| Project | IEEE 802.16 Broadband Wireless Access Working Group < http://ieee802.org/16 > |
| Title | Transparent Uplink Relaying for OFDMA |
| Re: | IEEE P802.16-REVe/D5-2004, Sponsor Ballot |
| Purpose | Adoption of proposed changes into P802.16e |

Figure AAA. TR operation.

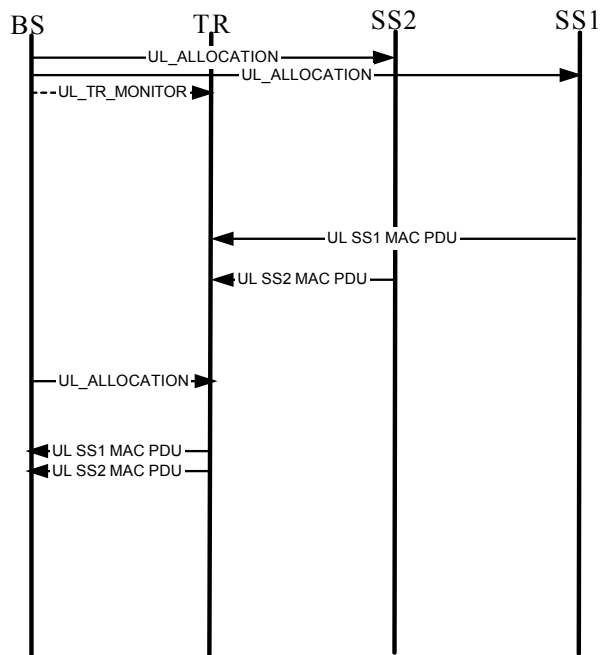
In order to improve data rates on the uplink, relaying some uplink transmission may be advantageous. Relaying on the uplink is performed by fixed entities called Transparent Relays (TR). The BS may allocate one or more TR to relay the data transmissions associated with a particular CID (e.g., a particular SS) on the uplink. The process is shown in Figure AAA. In the UL_MAP, the uplink resource allocations are sent to the transmitting SSs and an UL_TR_MONITOR IE is included to instruct a TR or a group of TRs to monitor the uplink transmissions associated with one or more SS CIDs. In the uplink, the SSs transmit, and the TRs monitor the transmissions they were assigned to monitor. The monitored transmissions are demodulated and decoded by the TRs so that they can be re-encoded and re-transmitted (relayed) in the next frame. In the next frame, in a second UL_MAP message, each active TR receives its resource assignment for the relaying transmission. This resource assignment is made per TR CID, or for a multicast group TR CID. When the assignment is made per a multicast group TR CID, these are T-relays are expected to simultaneously relay the monitored transmission providing a macro diversity gain.

The MAC PDUs are transmitted from a TR in exactly the same relative order as they were received and are modulated and coded with the Modulation Coding Scheme (MCS, based on the UIUC) specified in the UL_MAP_IE addressed to the TR. The MAC PDUs of each respective SS are encoded separately as if the BS had sent separate allocations for each SS that is being relayed. If the TR did not correctly decode the data from a particular user (CID), it does not relay that data and leaves this portion of the assignment empty.

Figure AAB. TR resource allocation. SC denotes subchannel.

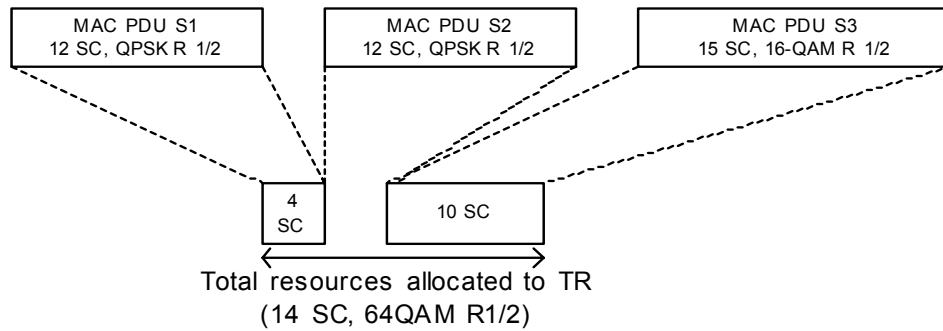
An example of TR resource allocation is given in Figure AAB. In the example described, the TR has to relay three transmissions: MAC PDU S1, MAC PDU S2, MAC PDU S3, whose assignments appeared in this same relative order in the previous frame. The TR receives its resource allocation (in an UL_MAP_IE) for relaying the three transmissions with 64-QAM $R=1/2$ and the necessary amount of subchannels to perform the relaying operation. The first PDU to be relayed, MAC PDU S1 is modulated and encoded with the new MCS and

mapped onto the first resources. The TR was not able to receive correctly MAC PDU S2, therefore it does not transmit anything for S2, but leaves blank the portion of the assignment resources where it should have relayed this PDU. Resources for relaying MAC PDU S3 are assigned after the resources that were provisioned for MAC PDU S2. This TR resource assignment process enables the BS to know where to find the relayed data for each MAC PDU even though the relay uses a different MCS than the SSs. Macro-diversity is also provided when multiple TRs are assigned to relay the same CIDs.
